## Product Change Notification – 2017/11

Product Line:	etherCON Chassis Connector	Part No:	NE8FDX-*6-W
Piece Part:	Sealing gasket	Part No:	91226311 BG 8801035
Engineering Change Notification:	46/2017	Date:	07.07.2017
Comments:	Modified sealing gasket with additional fastening washers.		
Affected products:	<ul style="list-style-type: none"><li>• NE8FDX-P6-W</li><li>• NE8FDX-Y6-W</li></ul>		
First Shipment of Modified Product:	K31

### Engineering Change Notice

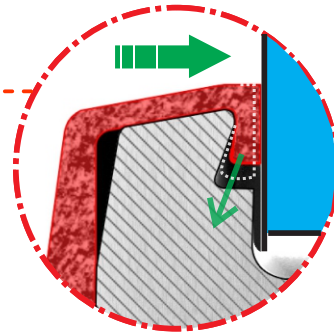
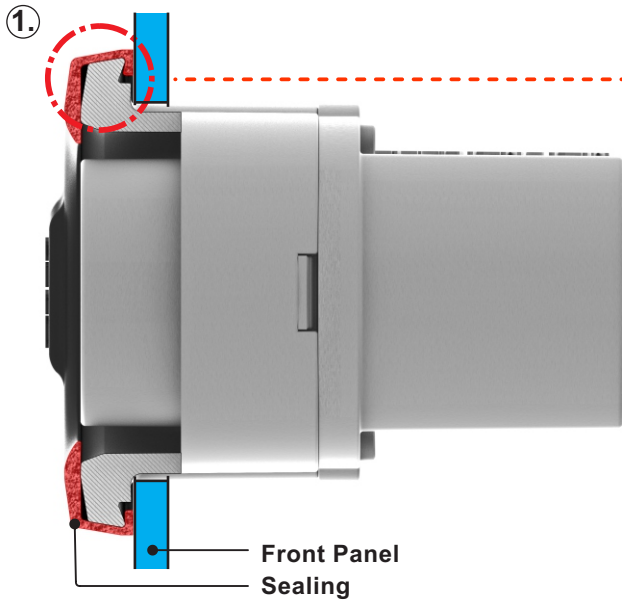
To improve and simplify the fastening of the gasket sealing, the diameter of the sealing screwholes is reduced. Additionally 4 conical washers are added.

The combination of modified sealing gasket and conical washer assures a proper fitment.

#### ATTENTION:

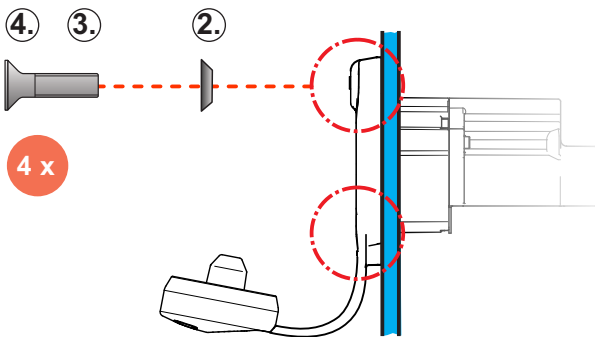
- ① Sealing must be positioned well
- ② Position the supplied washers
- ③ Diameter of countersunk screw head min. 5.0 mm and max. 6.0 mm\*
- ④ Maximum allowable torque 0.4 Nm
